PLANNING COMMISSION

Meeting Agenda

**SITE AND DESIGN REVIEW, FILE #: DR 16-02, SEQUOIA GROVE INDUSTRIAL PARK
PREPARED FOR THE MAY 9, 2016 PLANNING COMMISSION MEETING**

PREPARED BY: BRYAN BROWN, PLANNING DIRECTOR

SITE PLAN

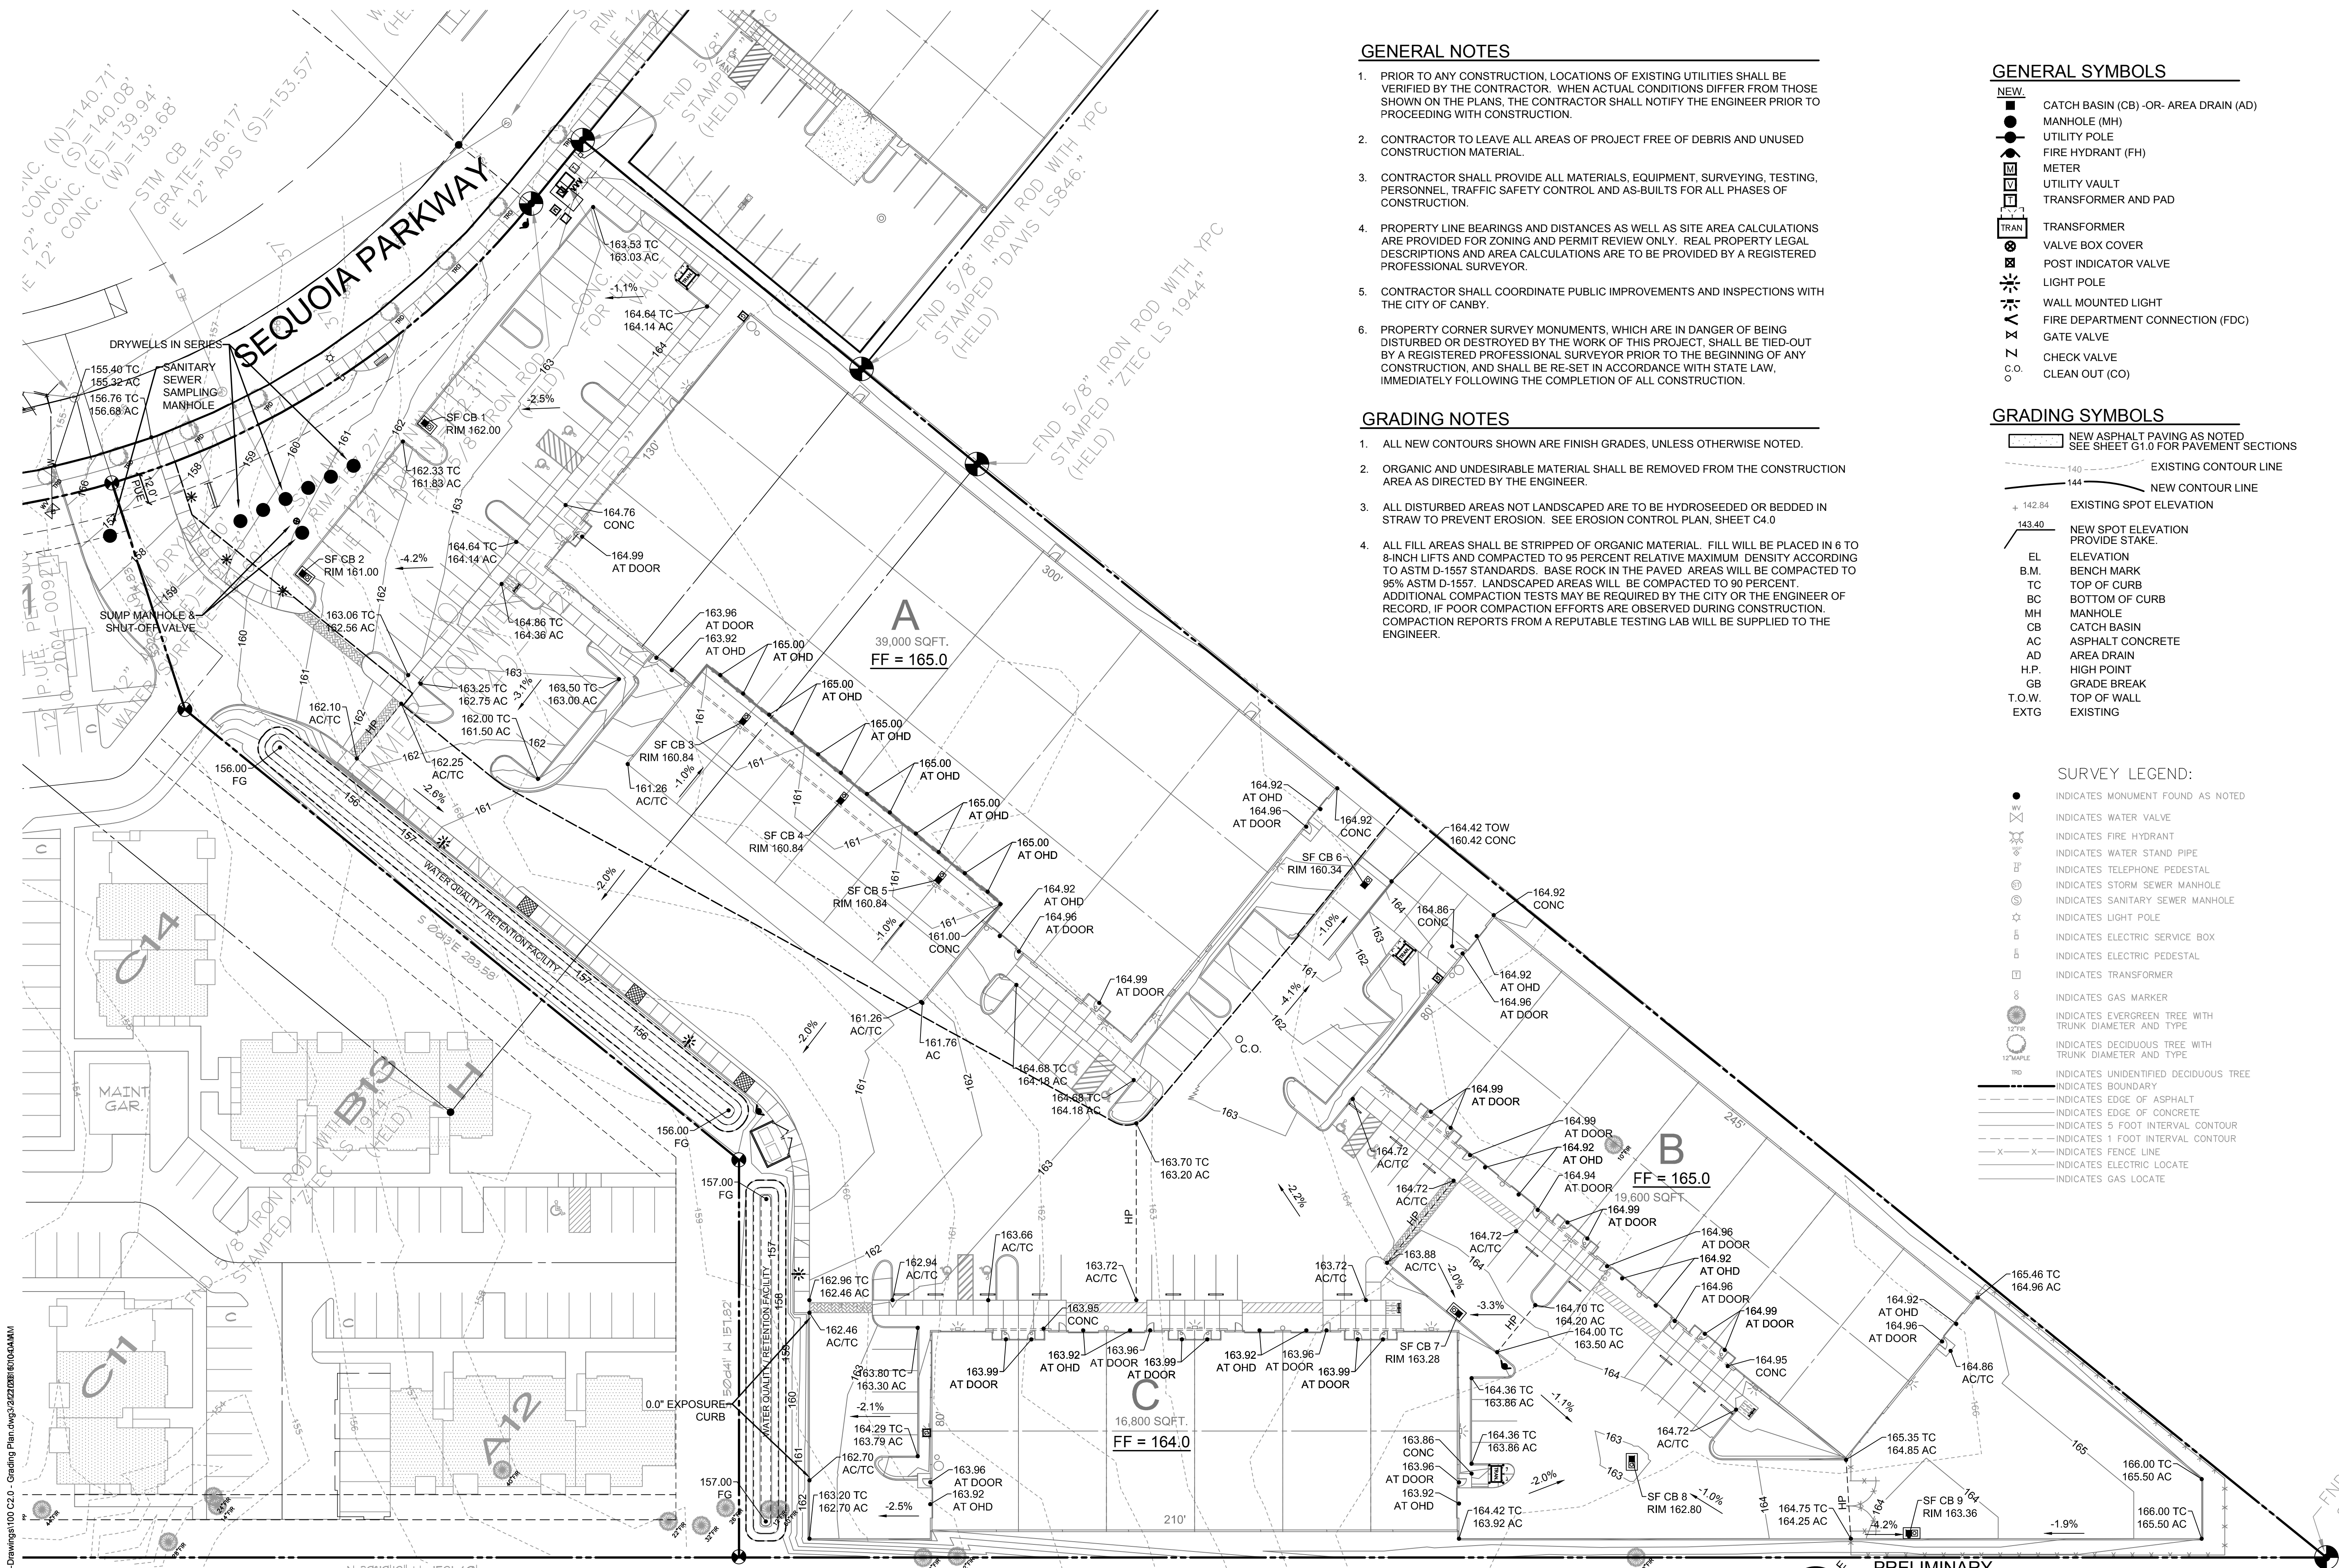
Findings: The applicant has reserved a location to the right of their driveway as you exit the site for a future monument sign on Sheet C1.0 labeled Note #20. It must be located outside of the 15 X 15' driveway sight distance triangle and appears to do so. A City sign permit and Clackamas County building permit is required for all signage.

3. A 6-foot wide concrete sidewalk will be required along the entire site frontage with a 5-foot wide planter strip. The submitted site plan (Sheet C1.0) generally reflects this requirement by scale.

4. A 6-foot wide concrete sidewalk will be required along the entire site frontage with Sequoia Parkway separated from the curb by 5-foot planter strip.

SITE LIGHTING PLAN

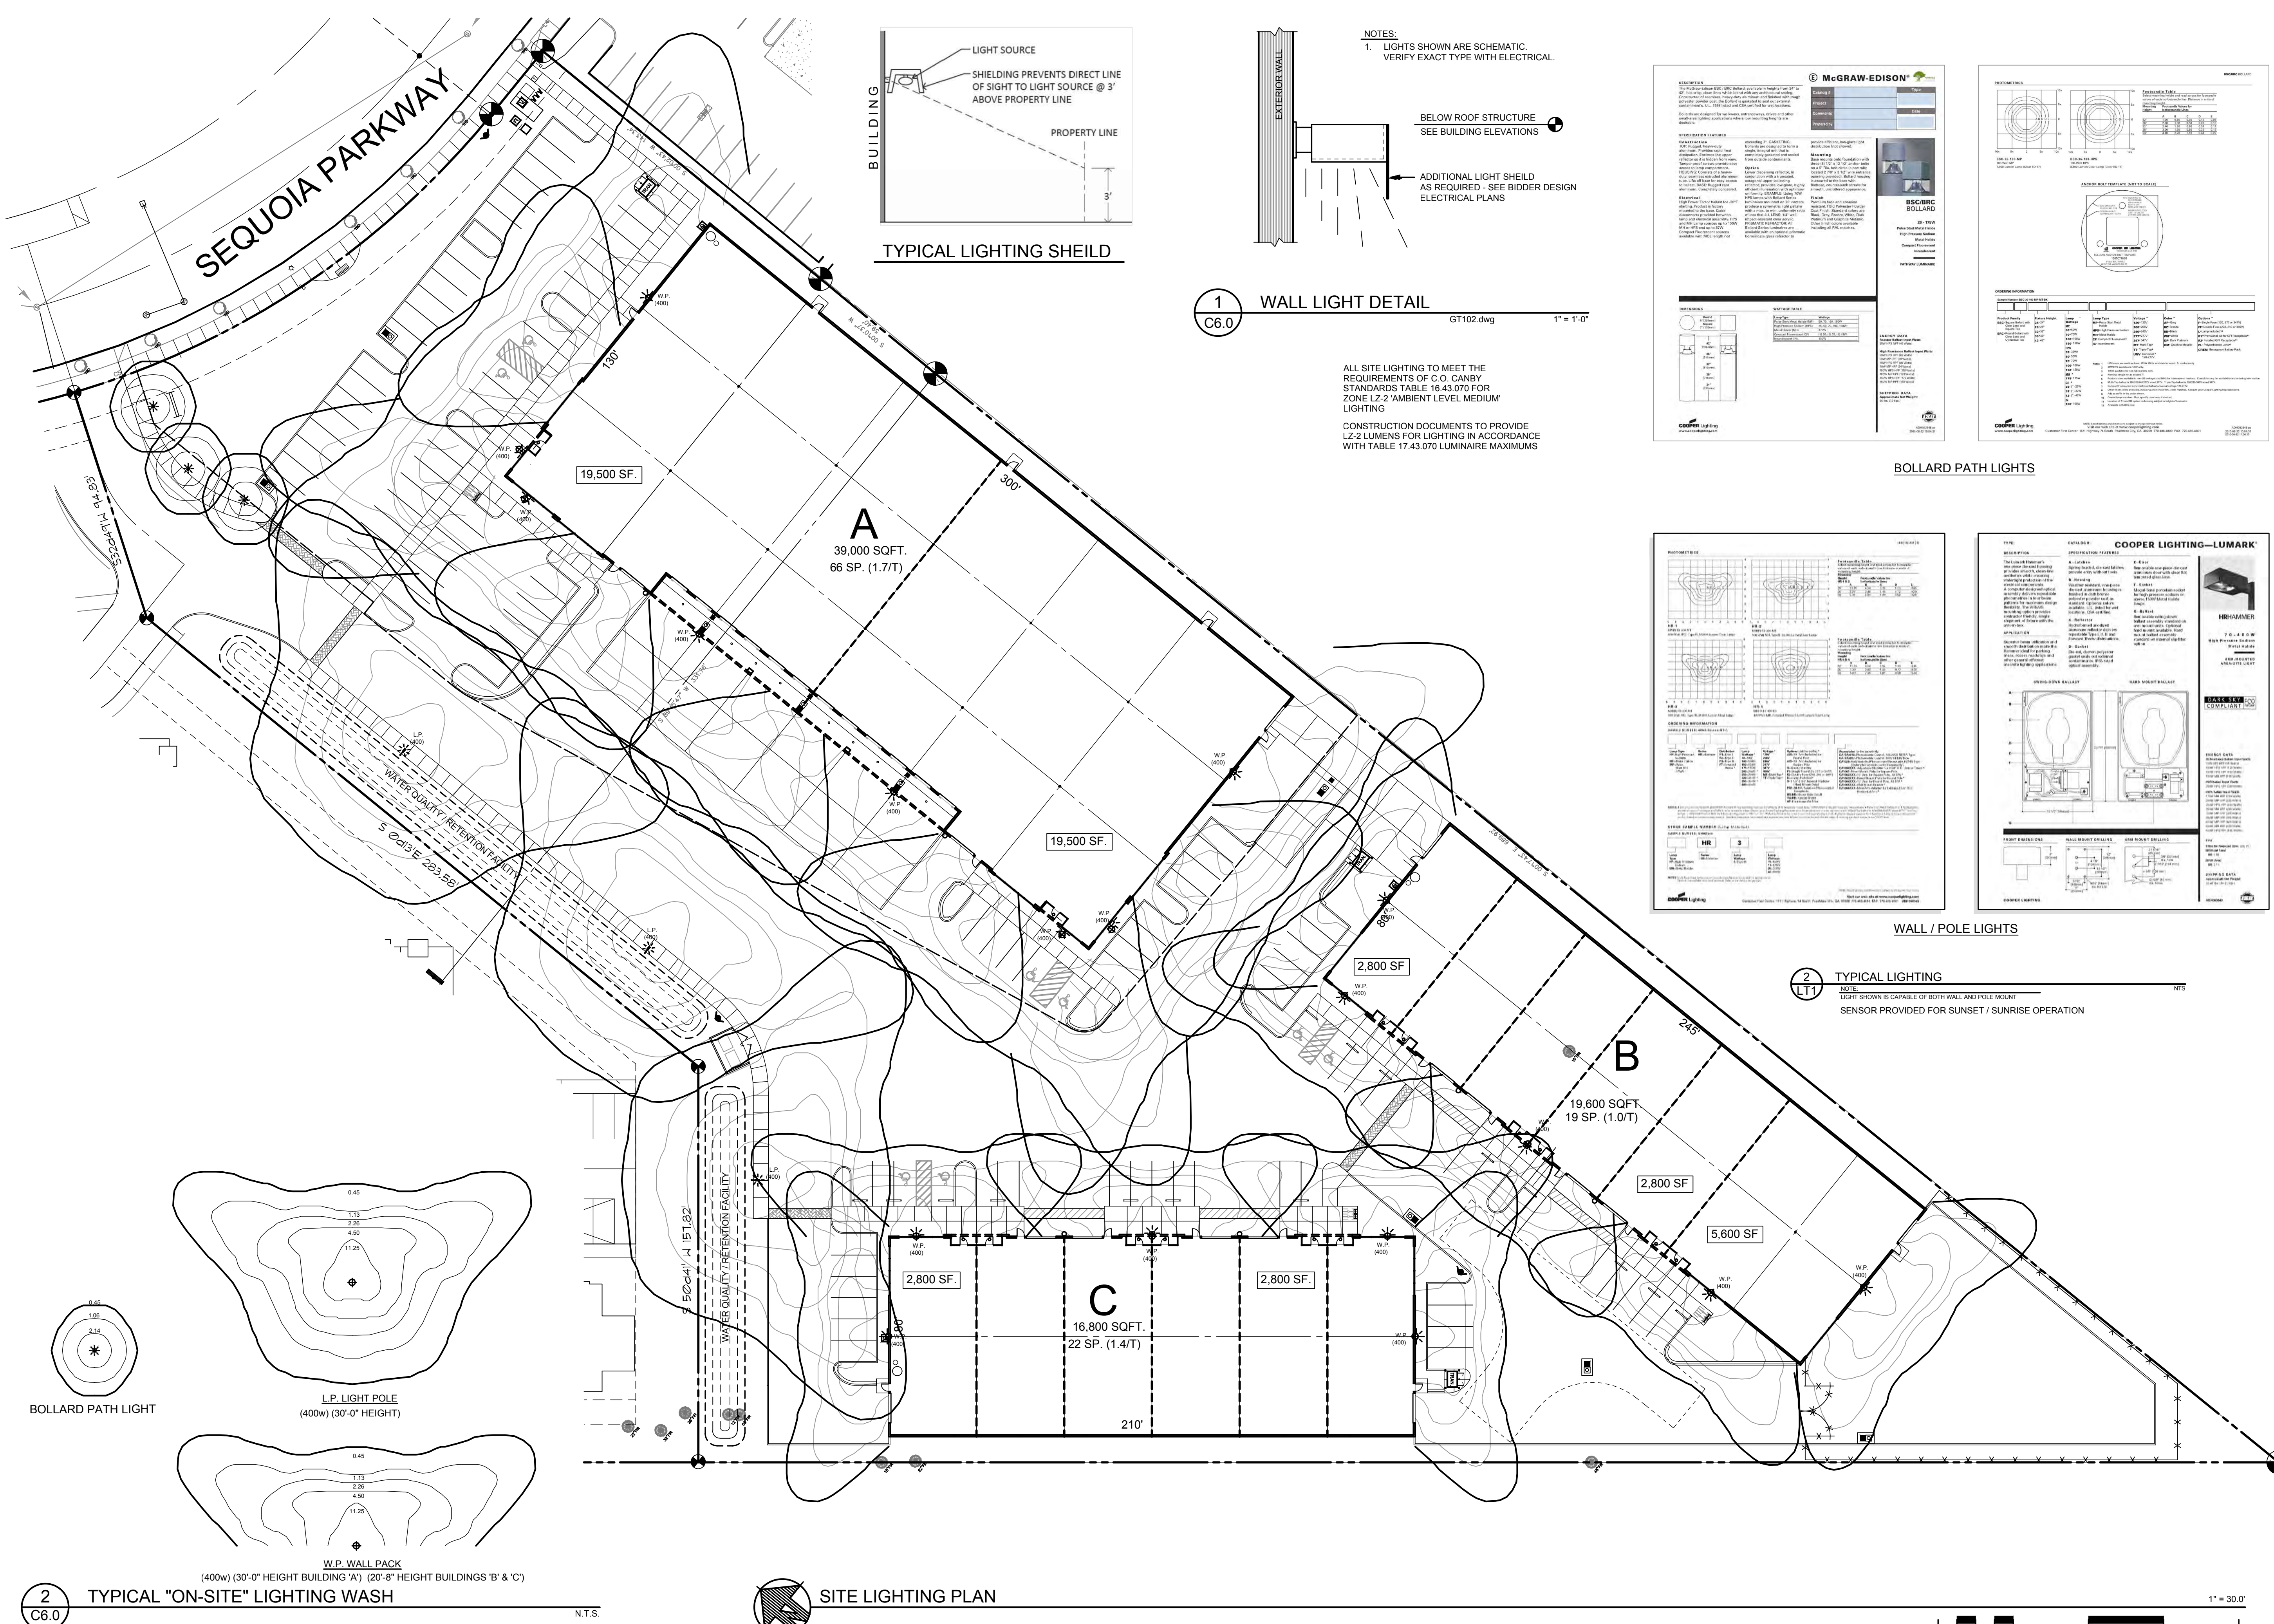
Findings: The applicant submitted a photometric lighting plan that indicates good lighting on-site around the front of the building and parking and drive areas and that the lighting will be shielded as needed to avoid light trespass across the adjacent property lines and to prevent glare toward the street. A note indicates the construction plans are to provide lighting documentation to show lumens for the
